- A. Title: Public Hearing for 11th Avenue Duplex (File Nos. CUP18-01 and DR18-09)
Presenter: Sarah Fox, Senior Planner

STAFF REPORT

11TH AVENUE DUPLEX

FILES: CUP18-01 AND DR18-09

A2.00

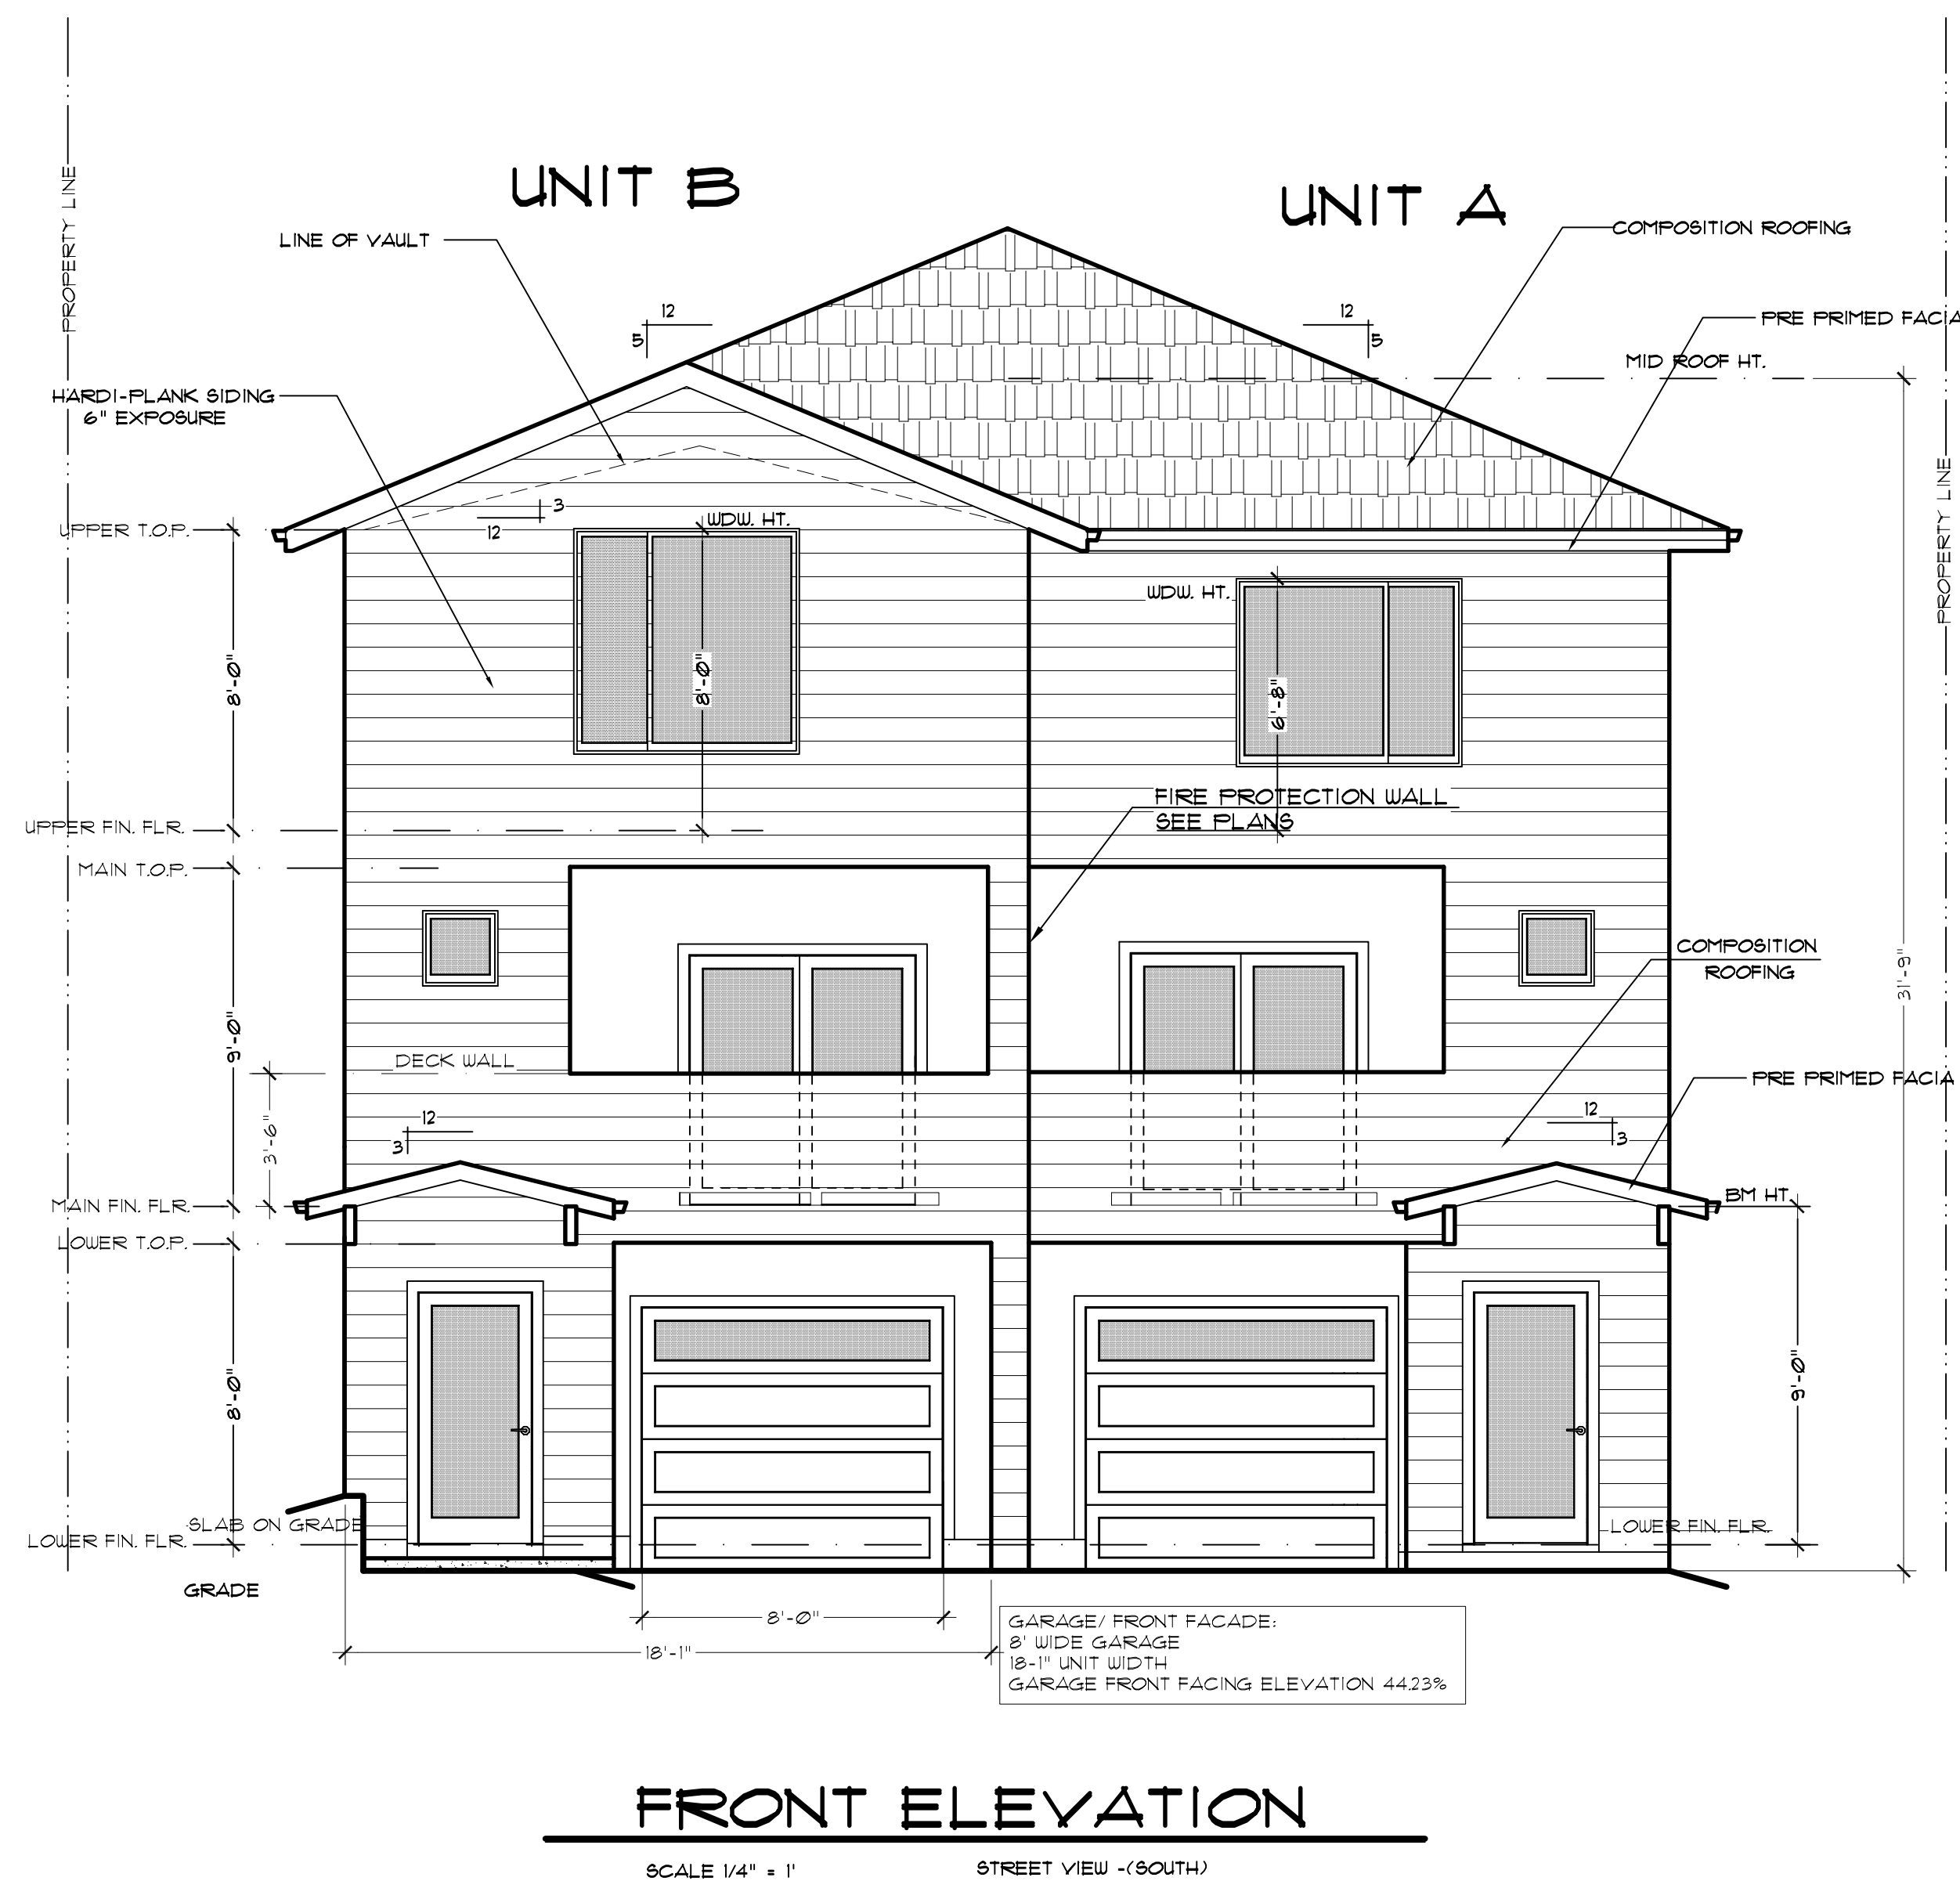
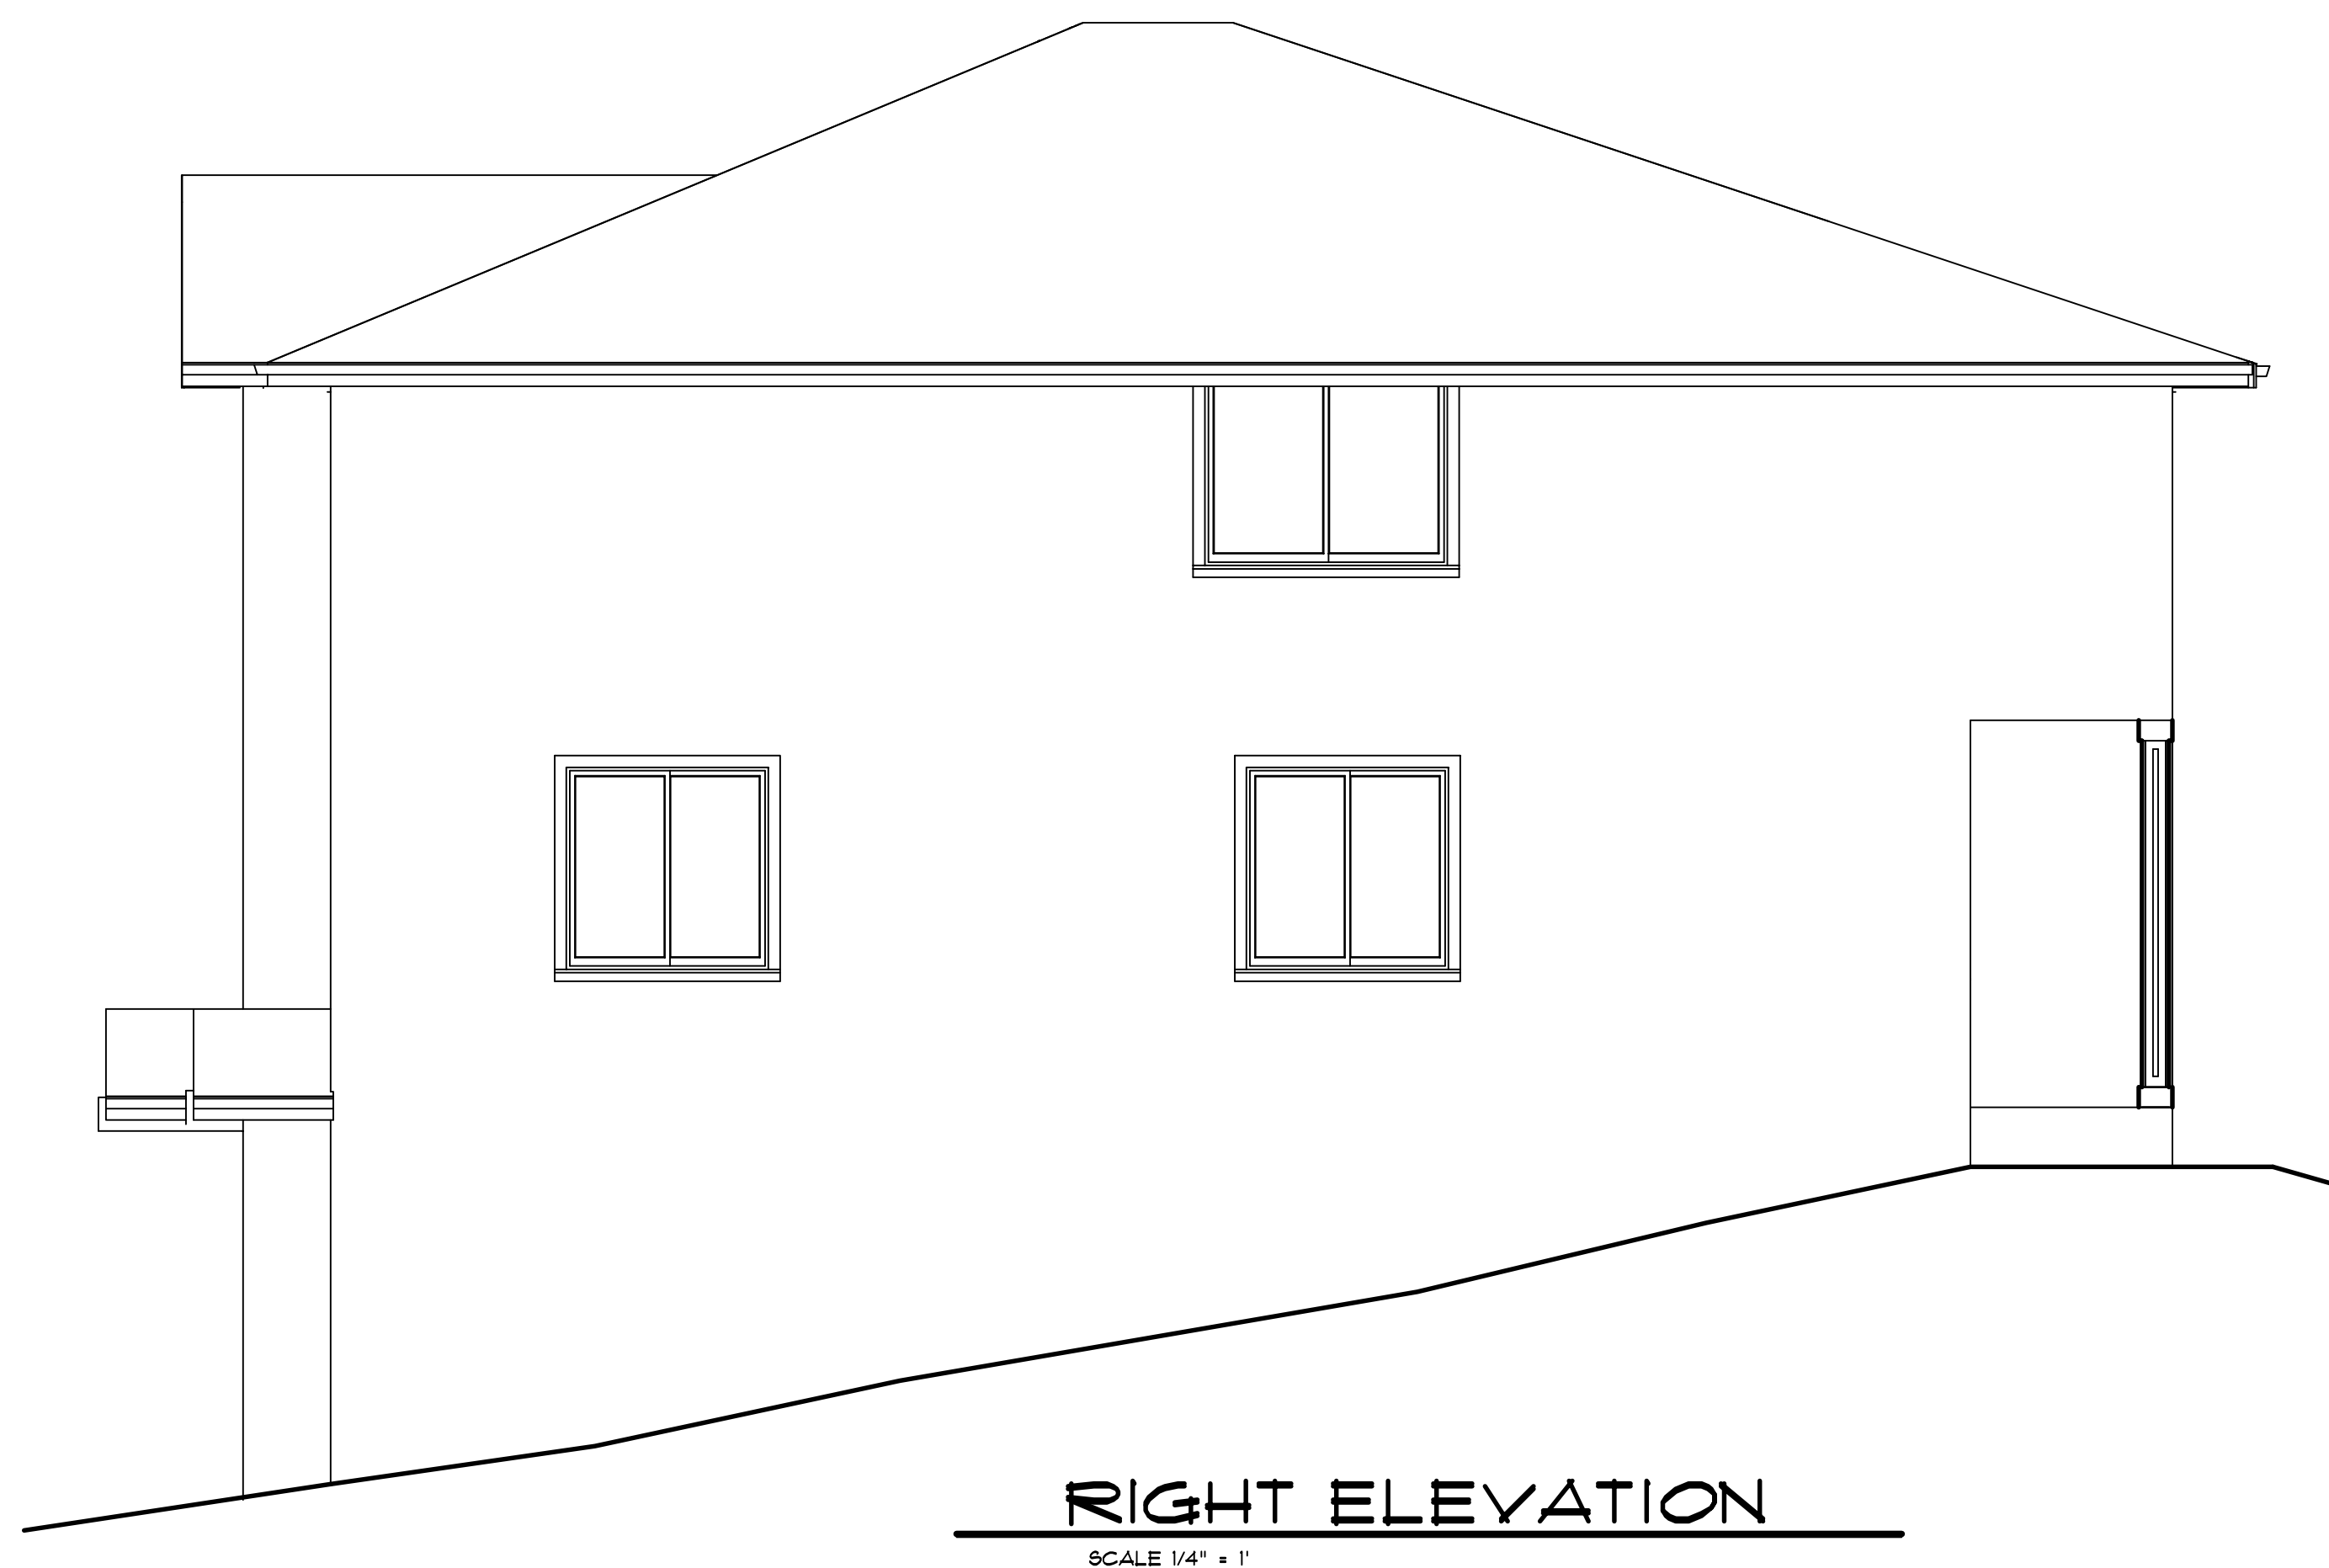
The applicant has proposed a design for the duplex that staggers the units rather than being flush with one another and the front doors are visible from the street. The front doors are set forward of the garage doors for both units as demonstrated on Sheet A2.00. Design Review criteria is discussed in the following section.

Findings: The garages will have a glass panel and are less than 50% of the front façade.
